COUNCIL BILL NO. 2016- 157

## EXPLANATION TO COUNCIL BILL NO: 2016-157

### RECORD OF PROCEEDINGS PRELIMINARY PLAT – PARAGON COURT

## Preliminary Plat - Paragon Court

**PRELIMINARY PLAT OF  
PARAGON COURT**  
A SUBDIVISION IN SPRINGFIELD, GREENE COUNTY, MO  
A PROPOSED ZERO LOT LINE CLUSTER SUBDIVISION  
OWNER/DEVELOPER: SHIRLEY PONTIUS  
8711 E. PINNACLE PEAK RD.  
SCOTTSDALE, AZ. 85255

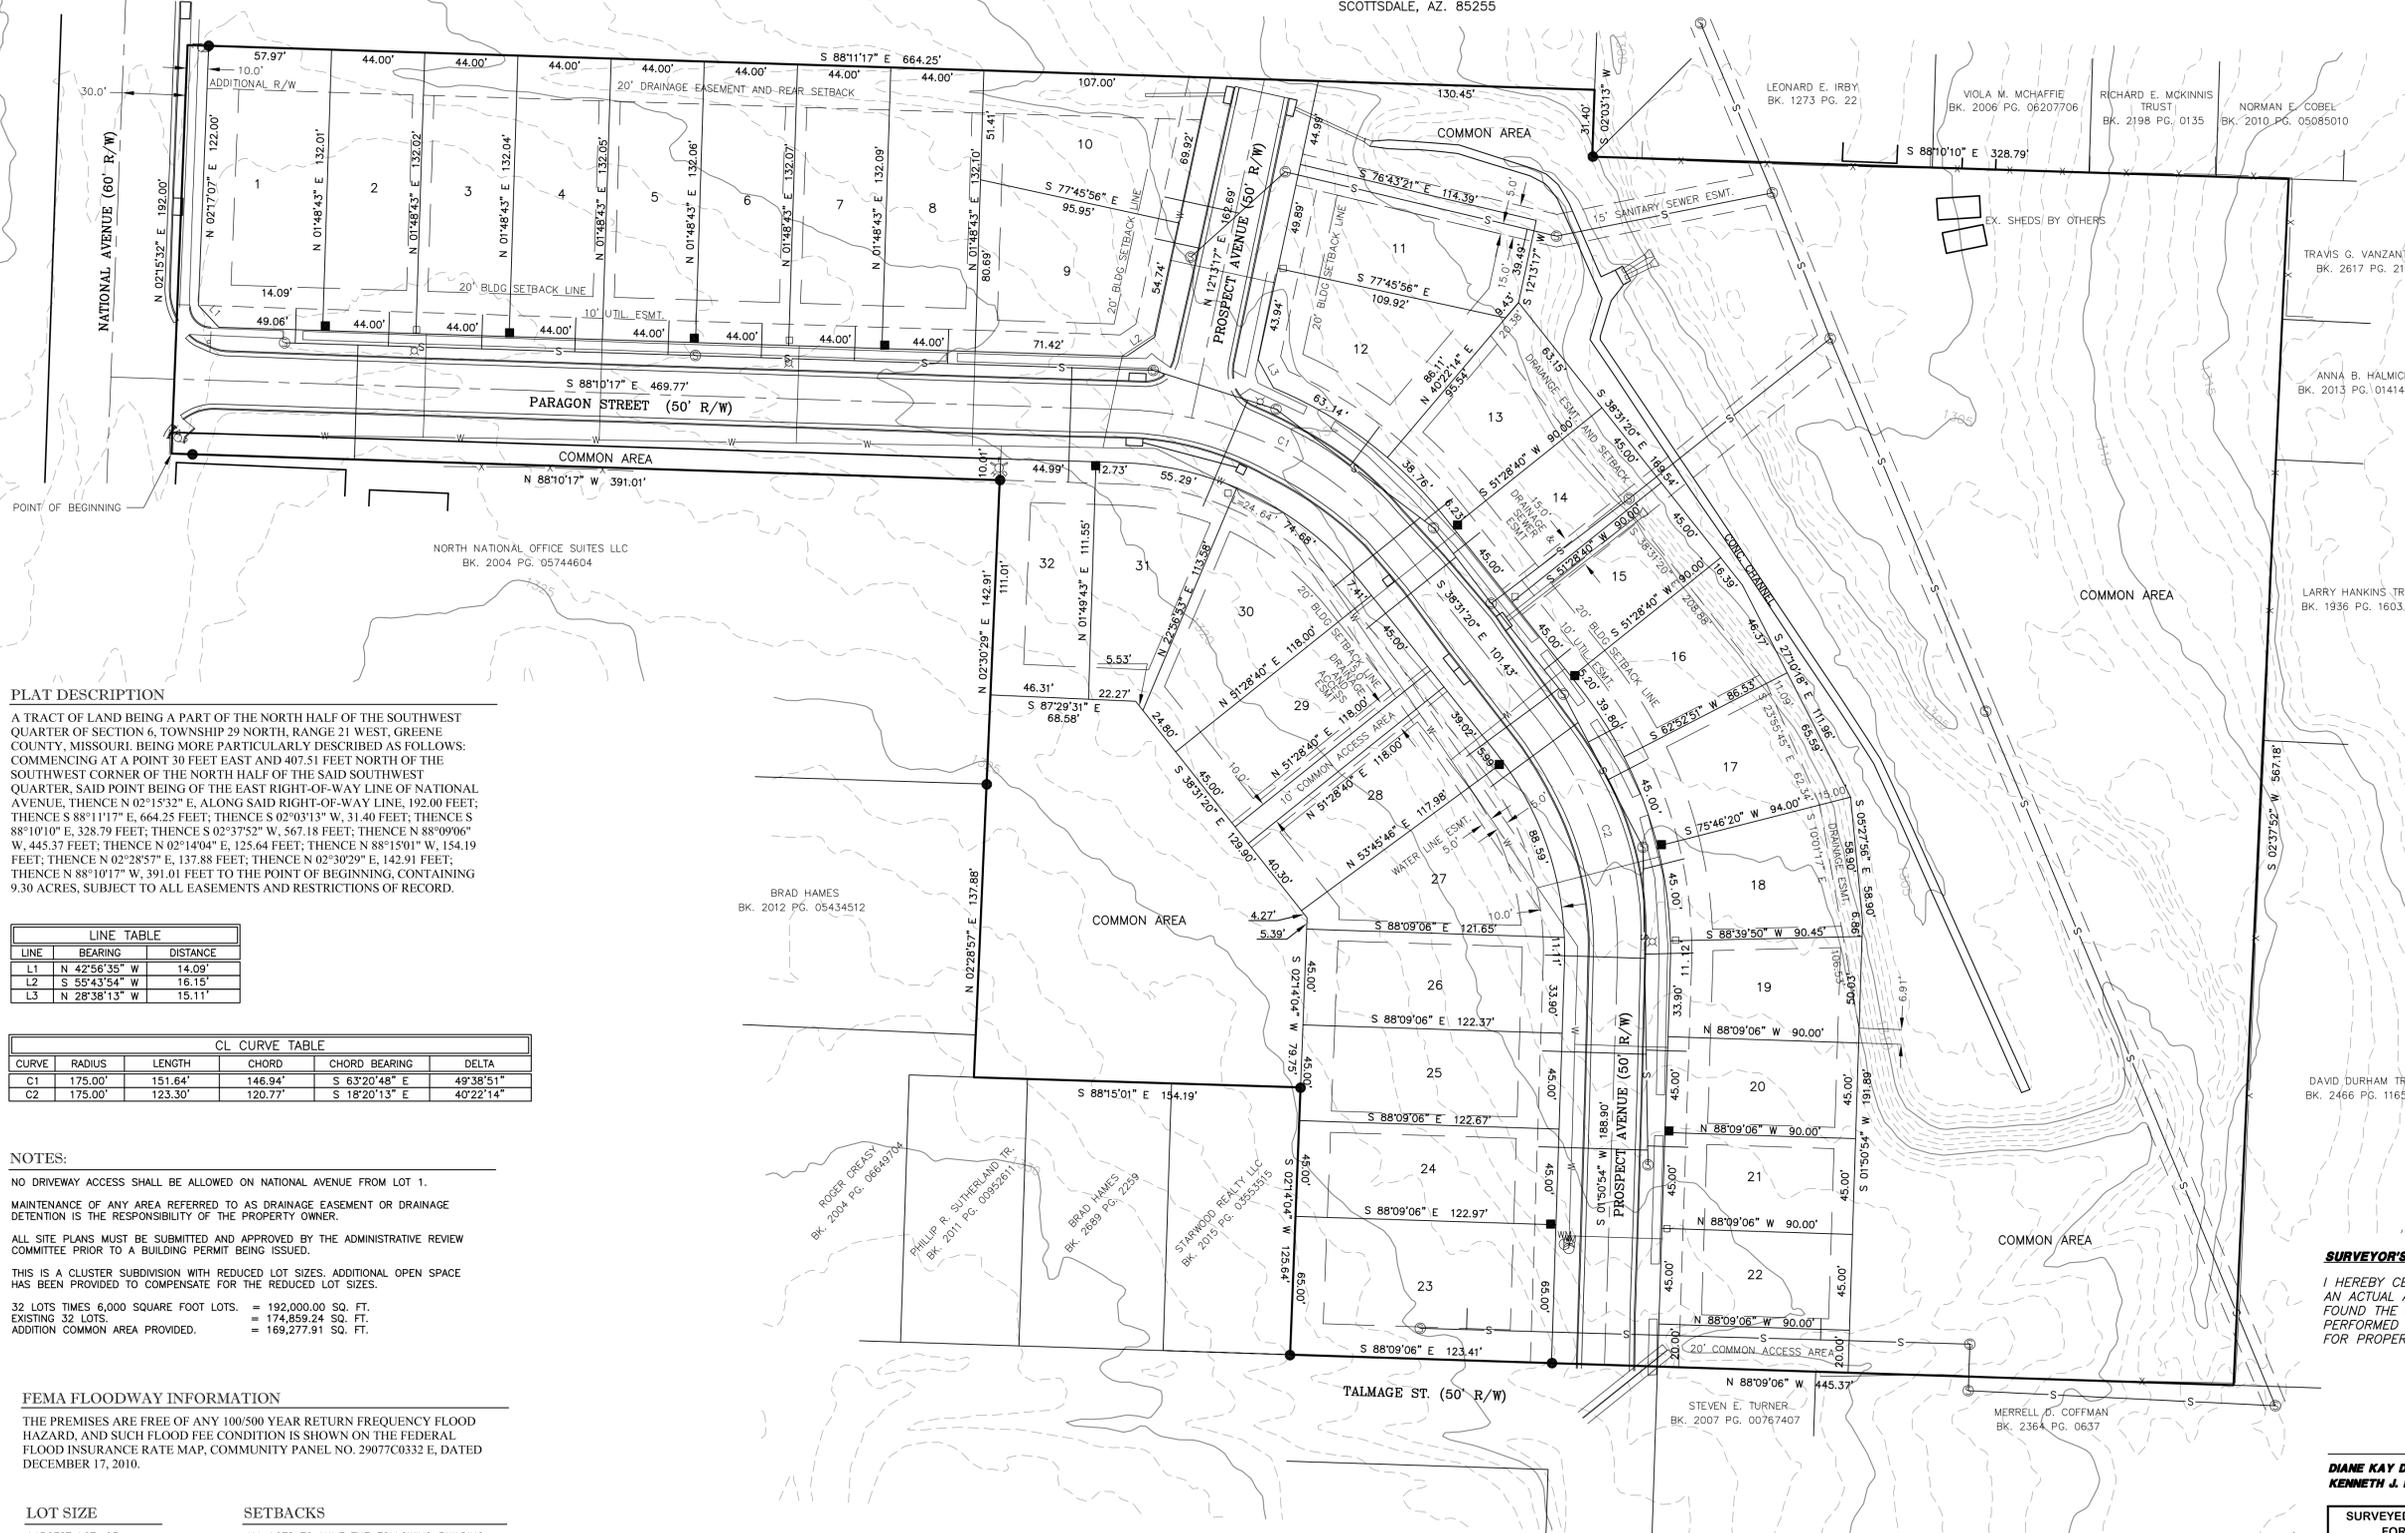
- b. The dedication of right-of-way for National, Paragon and Prospect Avenues are required as follows. Paragon and Prospect will be classified as local residential, which requires 25 feet of right-of-way from the centerline and 50 feet of right-of-way in total. National Avenue is classified as a secondary arterial, which requires 35 feet of right-of-way from the centerline.

- c. Change minimum width of sewer easements on plat and plans to 15 feet.
3. The developer shall meet all city and state erosion control regulations prior to disturbing the soil.

AT&T does not have facilities placed along Prospect Avenue. Please note that developer of this property will need to contact engineer Steven Beier 417-836-2761, 180 days prior to construction so facilities can be placed to serve this development. AT&T would request that the utility easement shown on the south side of Prospect Ave. read utility easement and footage.

Need to confirm water main location in lots 27-30. Our records do not show the water main encroaching this far into the lot. If it does then the water line easement makes sense. However the easement will be encroaching into the 20 foot building setback line.

Final acceptance of the original public improvement plans 5PW5713, were never accepted or completed. In order for the City to accept the public streets and stormwater associated with this plat, the following items will need addressed:

1. A new set of Public Improvement Plans will need to be submitted in ProjectDox. These may be the original set of public improvement plans with current survey data, elevations, etc. added to show the original set of plans were constructed correctly. Survey information shall include, but not be limited to: Manhole invert elevations, detention volume and elevations, and sidewalk elevations/cross-slope. Data should also be uploaded that clearly shows what remaining work will be done to bring all items into compliance, a bid submitted for this work, and fees paid.
2. The street will need to be cored to determine thickness of asphalt and base material in accordance with current City Standards.
3. The street will need to have an approved micro- seal placed on it to bring it to an acceptable maintenance level.
4. The City will allow the 4 feet sidewalks to remain. However, driveways must

accommodate 5 feet wide sidewalk sections.

5. Missing sidewalk shall be replaced.
6. Sidewalk ramp shall be added to tie sidewalk into Talmage Street.
7. Object markers shall be placed at dead-end street.
8. Storm boxes and pipes must be cleaned out and inverts poured if necessary.
9. Rip-rap pads must be added to storm inlets/exits as per original plans.
10. Also, sewer must be tested and cleanouts added as per Environmental Services comments.

Preliminary plat is acceptable, but the following previous comments will need to be addressed before final plat approval:

1. Prospect Avenue and Paragon Street are not public streets. The streets will need to meet current City of Springfield public works standards before the city will consider them to be accepted into the city street system.
2. The size of the lots are small. Access may need to be shared by two lots (for example, Lots 1&2; Lots 3&4, Lots 5&6, etc) if the lots are developed as shown on the preliminary plat. Access must meet city code requirements specified in Chapter 98-117 - Residential Driveway Approaches.
3. No access from any lot to National.

1. Prepare and submit AS-BUILT plans on subdivision.
2. Change minimum width of sewer easements on plat and plans to 15 feet.
3. Collect Inspection Fees on unfinished or reconstructed portions of the subdivision.
4. Require the current specifications on clean outs at the ROW and visually inspected the laterals. Contractor to provide CCTV (Closed-circuit television) of laterals to inspector.
5. Environmental Services will waive the requirement for tracer wire.
6. Shoot important elevations, such as flow lines, manhole lids, etc. Show as-built pipe grades on plans.
7. Vacuum, pressure and mandrel testing need to be performed by the developer's contractor. Any defects from this testing must be corrected.
8. There are three manholes with the wrong lid and frame that need to be corrected. One lid is welded shut. Could not be inspected. One manhole has an offset frame

that needs to be corrected.

9. CCTV revealed 8 point repairs that need to be corrected.
